## ADDENDUM 1

### ADDENDUM DATE: December 26, 2024

- PROJECT: McGee Building "One Door" Renovation Phase 1 3505 Arendell St Morehead City, NC 28557
- OWNER: Carteret Community College 3505 Arendell St Morehead City, NC 28557
- ARCHITECT: Smith Sinnett Architecture, P.A. 4600 Lake Boone Trail, Suite 205 Raleigh, North Carolina 27607
- BIDS DUE: 2:00pm January 07, 2025 McGee Board Room 3505 Arendell St Morehead City, NC 28557

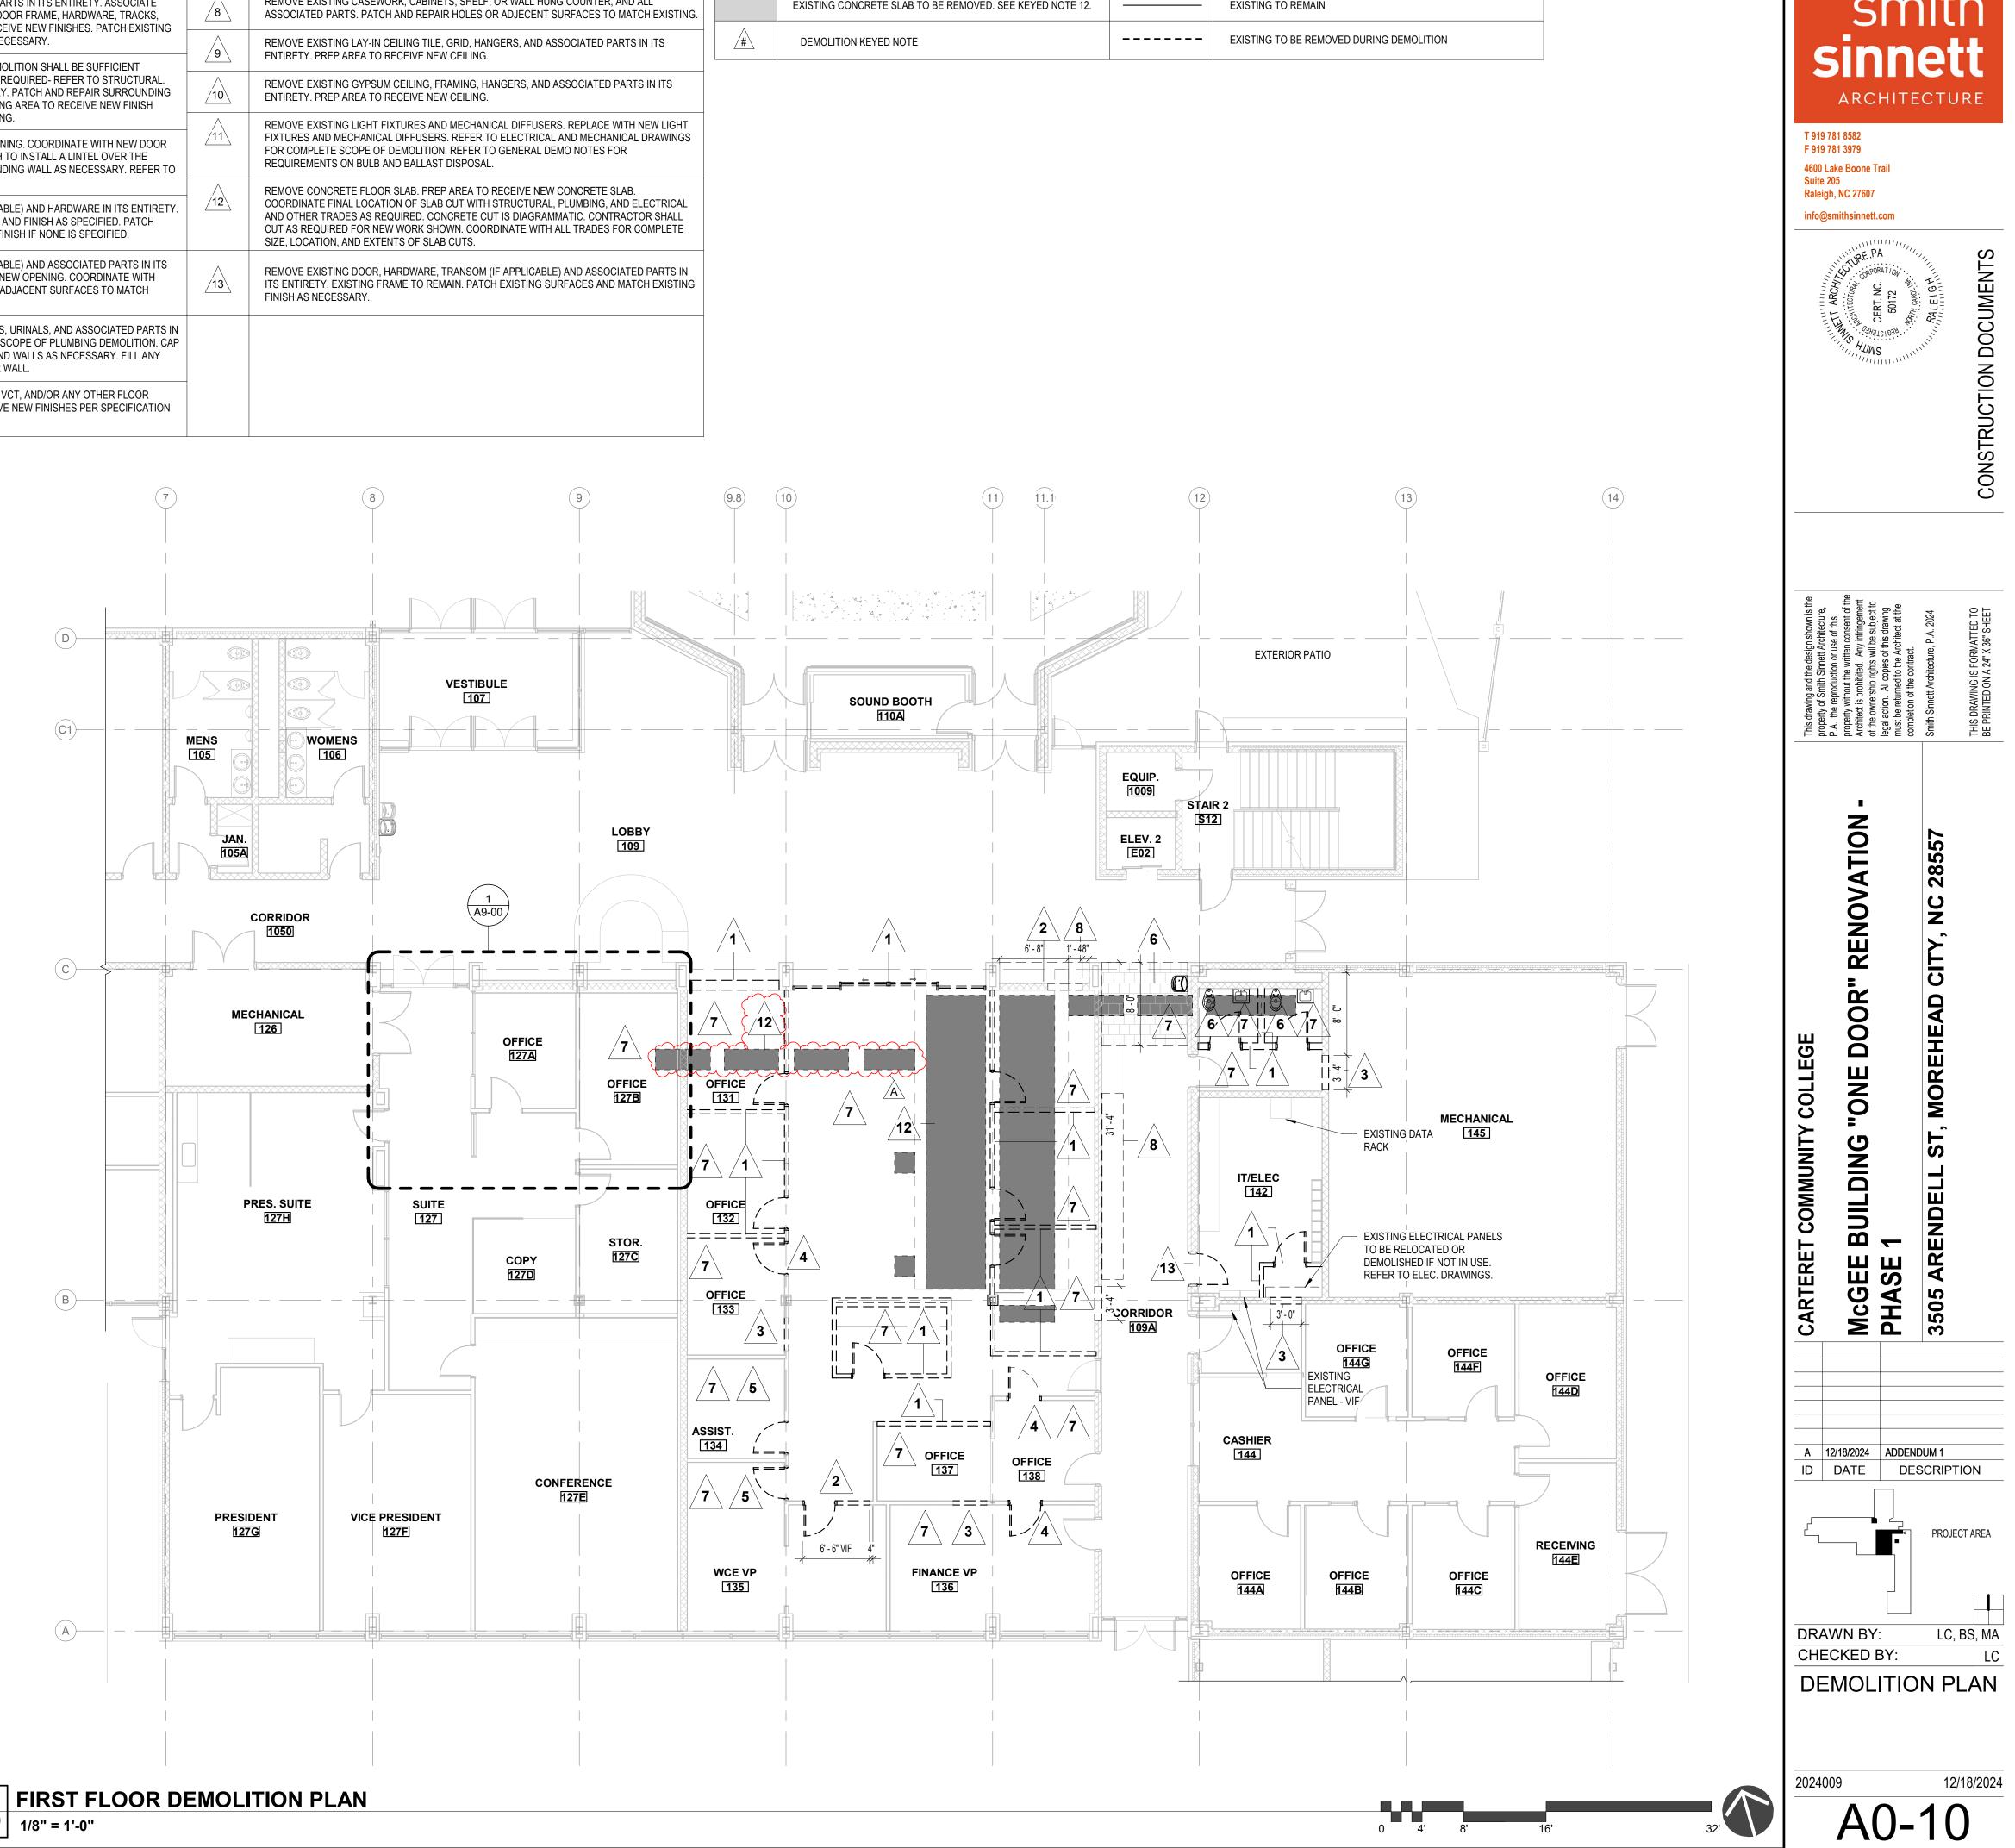
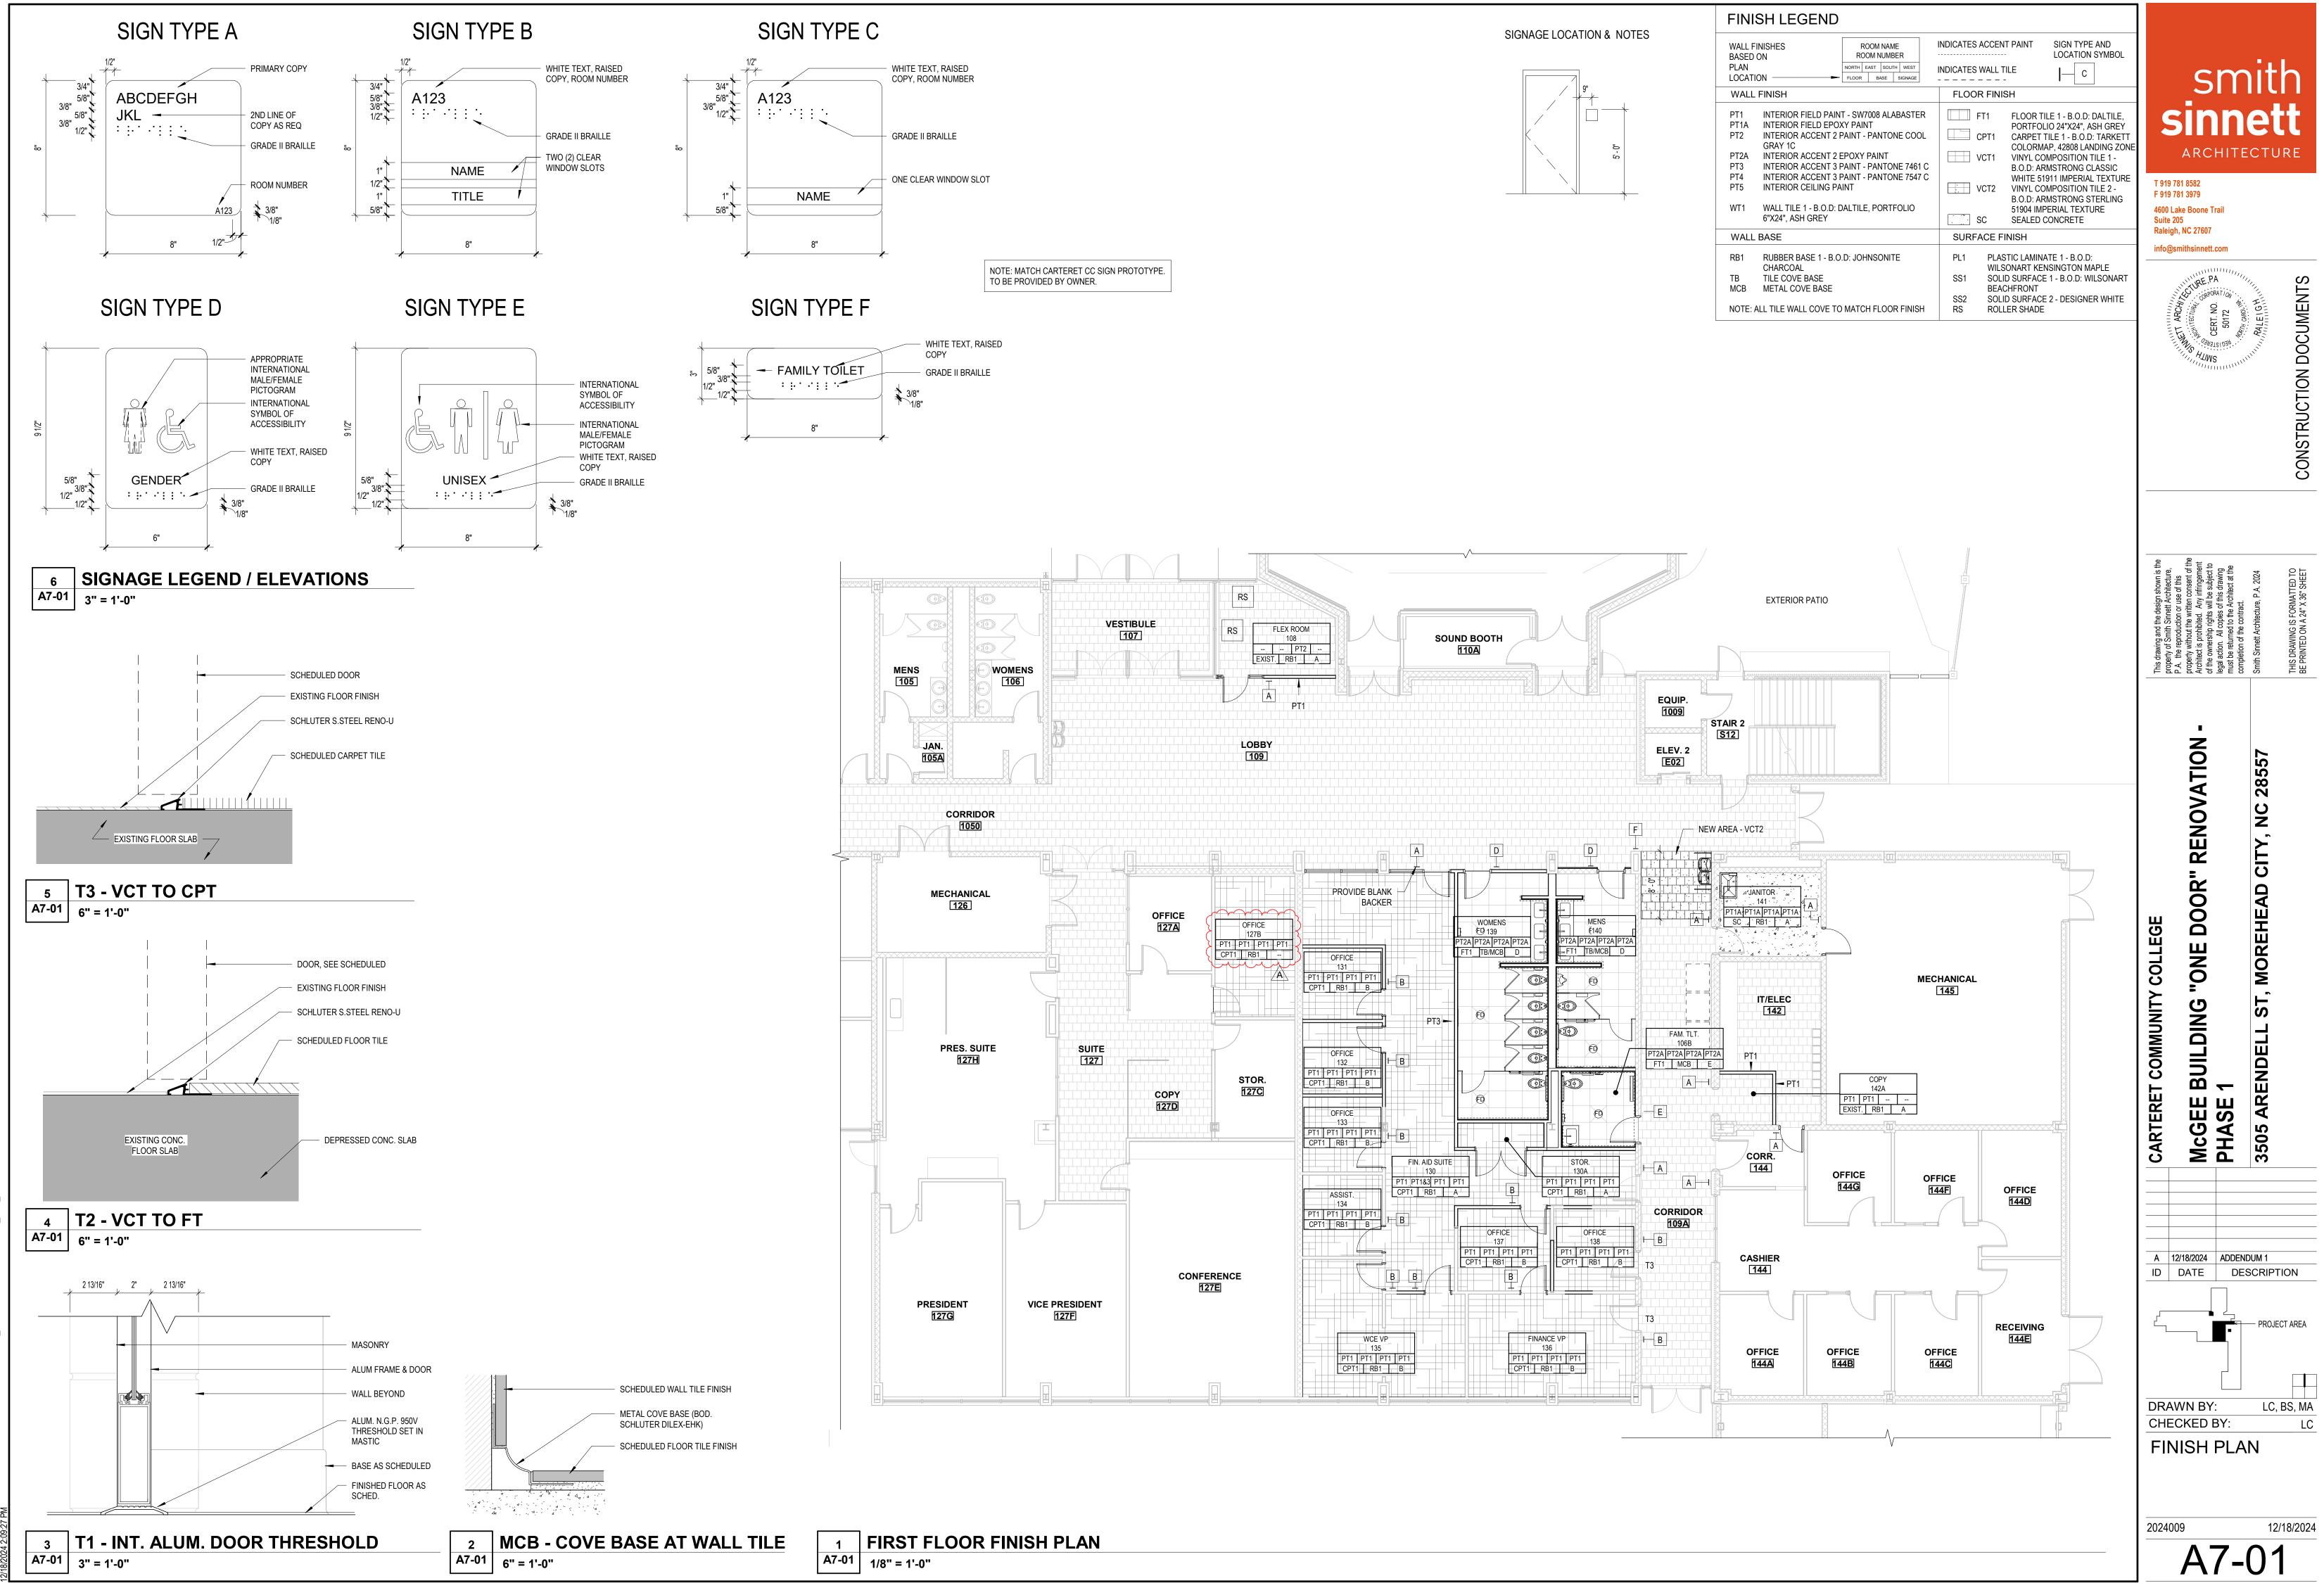
- 1. REVISION: A0-10, A7-01, A9-00.
  - a. The demo and installation for a stub-up in the breakroom is to be in base bid.
  - b. Replace Sheets A0-10, A7-01 and A9-00 with the updated sheets attached in this Addendum.
- 2. REVISION: E1, E3.
  - a. Replace Sheets E1 and E3 with the updated sheets attached in this Addendum.
- 3. REVISION: P1, P2.
  - a. Replace Sheets P1 and P2 with the updated sheets attached in this Addendum.
